MEMORANDUM

CANIATAD ADEILAD RHESTREDIG AR GYFER NEWIDIADAU I WAL FFIN / LISTED BUILDING CONSENT FOR ALTERATIONS TO BOUNDARY WALL

NEWIDD DEFNYDD O GAREJ DOMESTIG I ADEILAD GOFAL DYDD I GWN / CHANGE OF USE OF DOMESTIC GARAGE TO DOG DAY CARE BUILDING

17 RHOS BERSE ROAD, COEDPOETH WREXHAM LL11 3BT

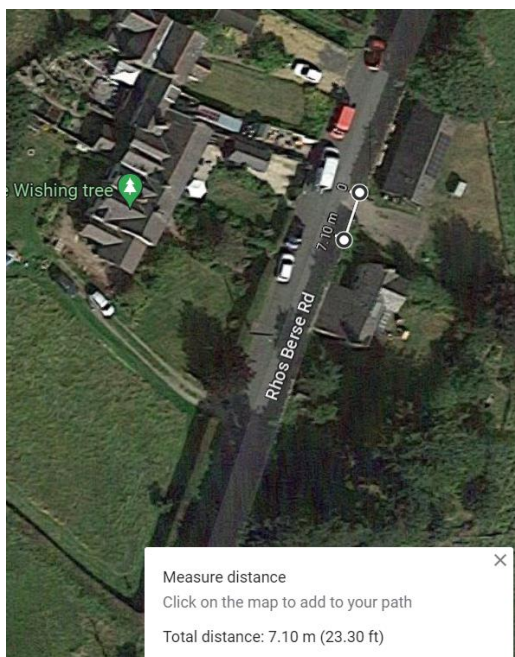
We are unable to support any reduction to less than a 7m wide opening in the wall unfortunately.

In the absence of a full design with swept path analysis, and drawn up AutoCAD details I have visited the site and made an approximate assessment of visibility splays, and believe that there will only be a true visibility splay of between 15-20m maximum even with a 7m opening. Whilst the majority of vehicles will travel around 30mph, there is potential for greater speeds. So 15-20m falls well short of desired standards but we are seeking to improve an existing situation as best we can within reason.

It is noted that vehicles can, and do park opposite, as can be seen on google maps, which further restricts the angle at which cars can enter and leave the applicants property. This also brings passing traffic closer to the applicants access in both directions.

The soft verge measures approx. 1.3m. Consequently the set back for a visibility splay is typically between 0.7m and 1.1m within the boundary for either a 2m or 2.4m set back.

Reversing out should be avoided at all costs unless a banks persons is present. This is a low risk as adequate turning distances are available within the yard.

A condition is required to secure the submission of an Operational Management Plan or Statement committing to this arrangement, as if the situation changes and frequent drop offs and collections
